Economic Commission for Europe

Convention on Road Signs and Signals (1968)

Proposal for amendments to Annexes 1 and 3

Submitted by the Chair of the Group of Experts on Road Signs and Signals and the secretariat

**TELEPHONE**

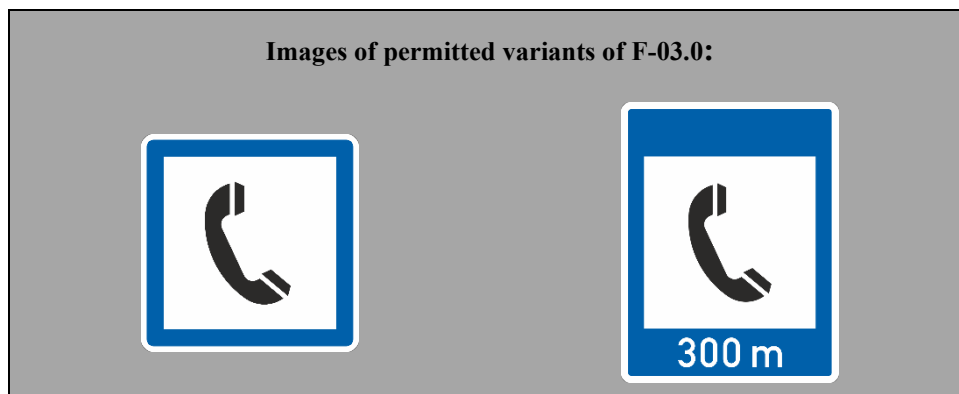
F-03.0 "~~TELEPHONE~~" notifies of a location of a telephone.

**FILLING STATION**

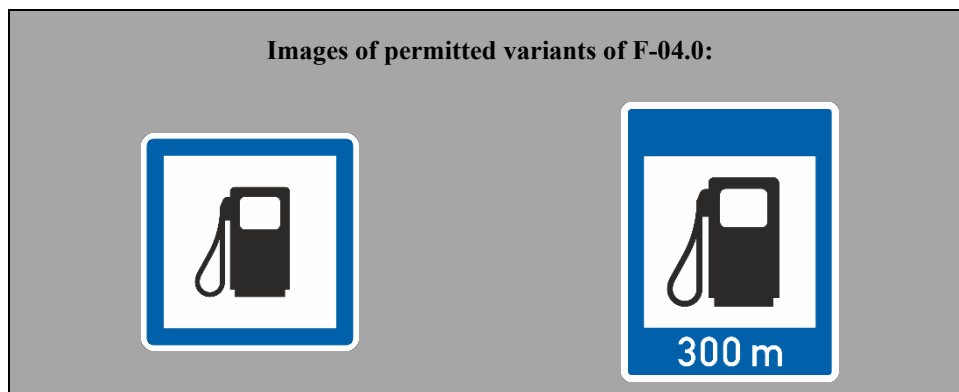
F-04.0 "~~FILLING STATION~~" notifies of a location of a filling station

EMERGENCY TELEPHONE

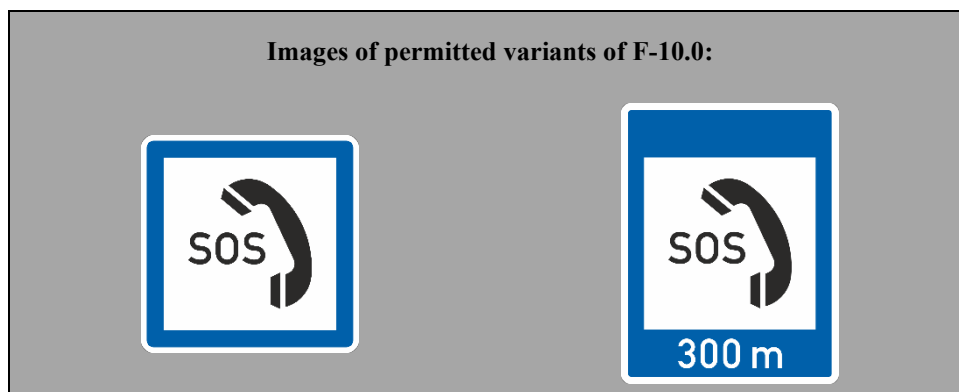
F-10.0⁶⁵ "EMERGENCY TELEPHONE" — notifies of a location of a telephone for emergency calls. The symbol may also be red.

**EXTINGUISHER**

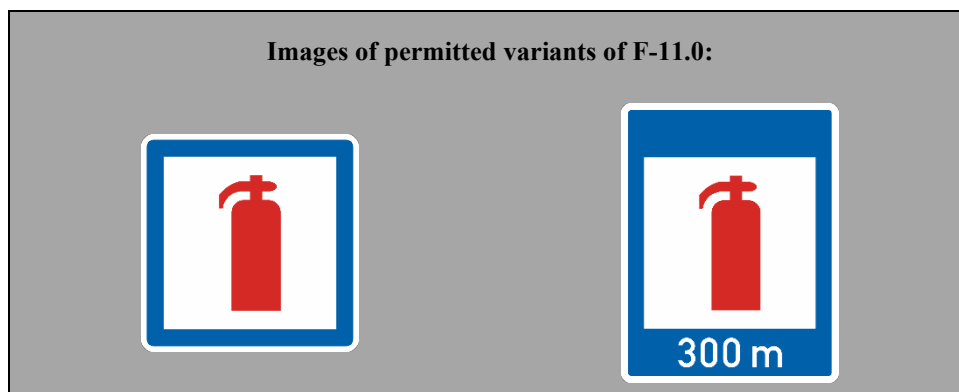
F-11.0⁶⁶ "EXTINGUISHER" ~~See footnote~~ — notifies of a location of an extinguisher. The symbol shall be red.

ESCAPE LANE

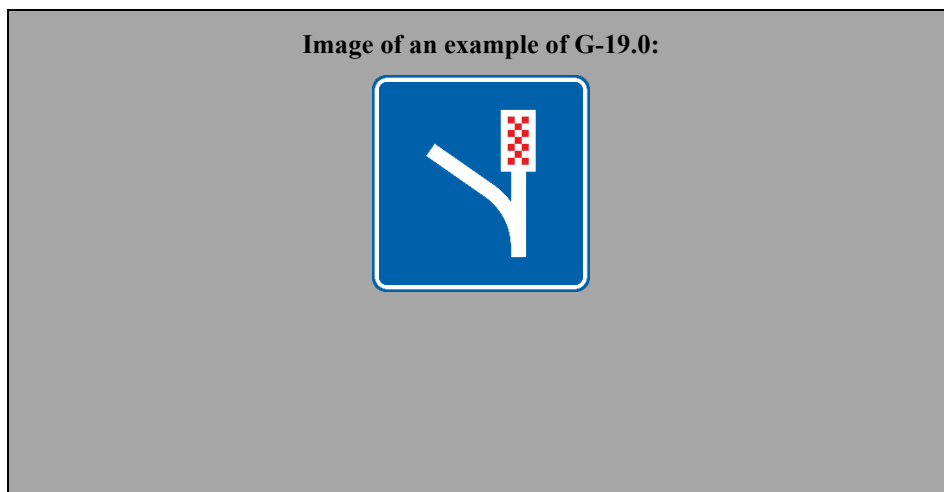
~~Sign G-19~~ **G-19.0 "ESCAPE LANE" shall be used to notifies drivers of an escape lane on a steep descent. This sign, with an additional panel plate displaying the distance to the escape lane, should be placed in conjunction with sign A-2 A-02.1 or A-02.2 at the top of the descent, where the danger zone begins and at the entry to the escape lane. Depending on the length of the descent the sign should be repeated as necessary, again with an additional panel distance plate displaying the distance to the escape lane. The symbol shall be white and red. The symbol It may be varied depending on the location of the escape lane in relation to the road concerned. It shall be reversed for traffic keeping to the left.**
